9800 Medical Center Drive, Limited Site Plan Amendment, 81995045E and Final Water Quality Plan

SITE PLAN 81995045E
9800 MEDICAL CENTER DRIVE

SHEET S1.2

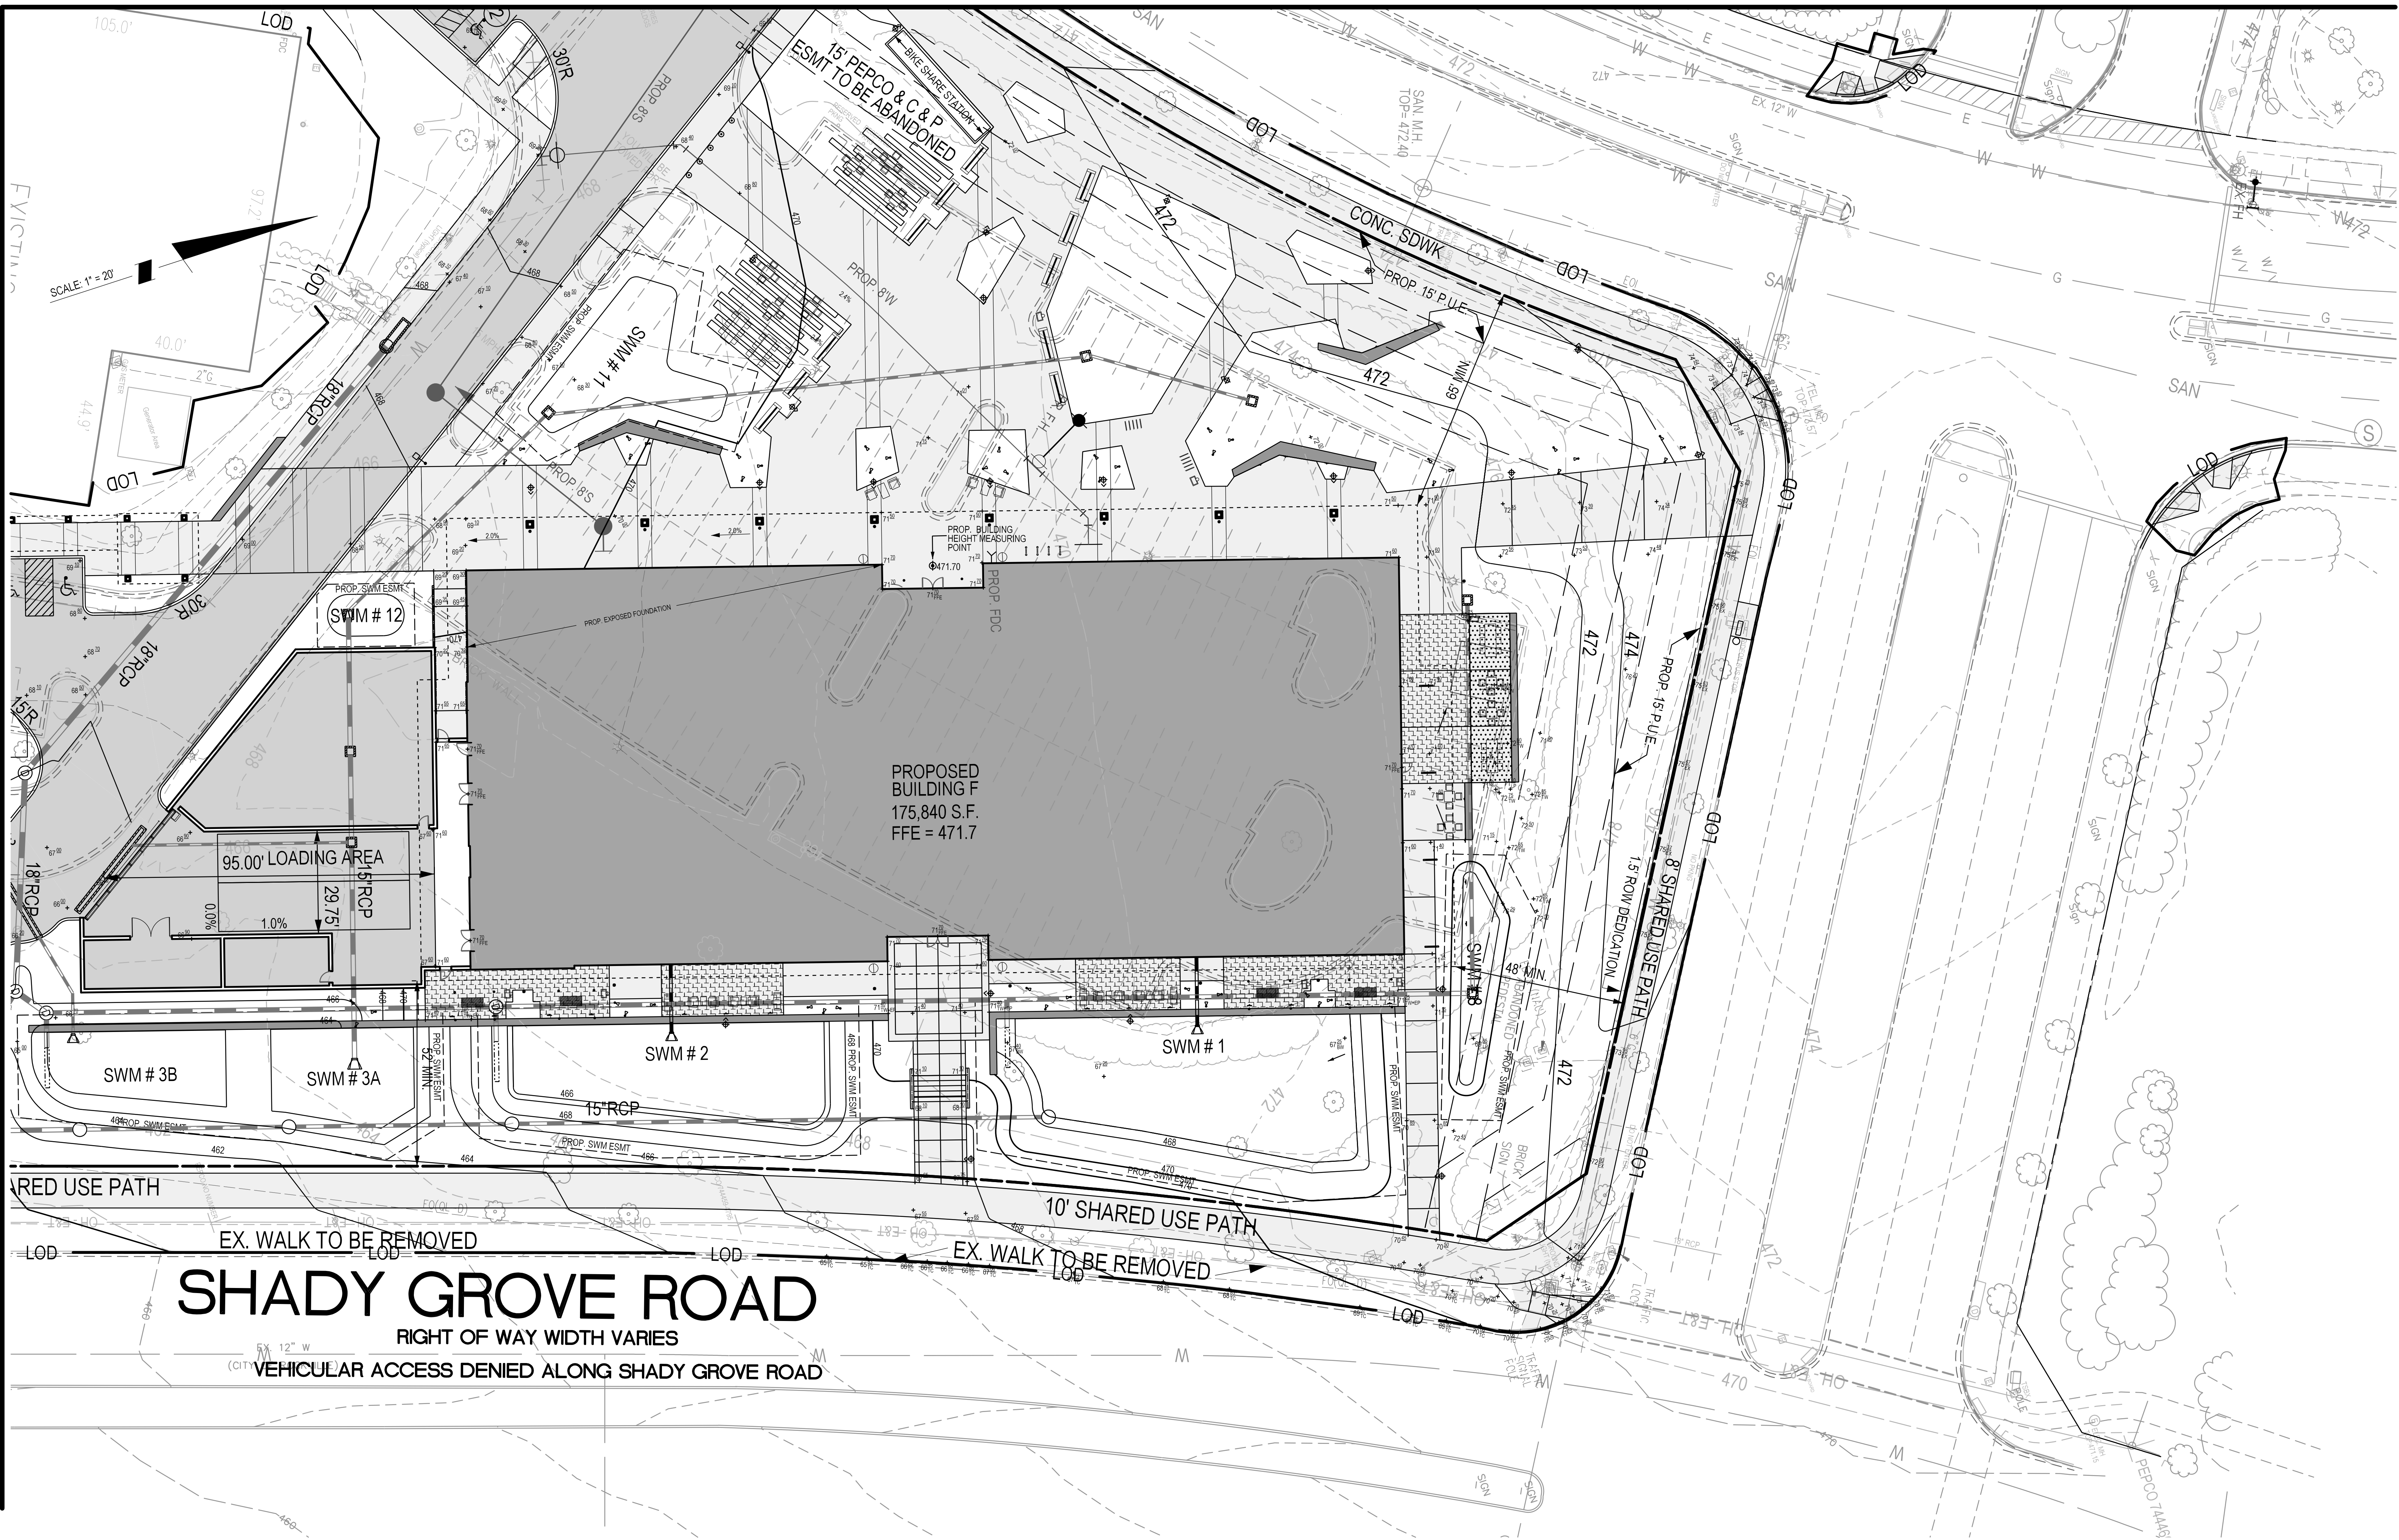
- c) Modify the location of the parking structure's southern stair tower from the southeast corner to the southwest corner of the parking structure.
- d) Ensure the proposed handicap ramps and pedestrian refuge islands are aligned at the intersection of Medical Center Drive and Medical Center Way.
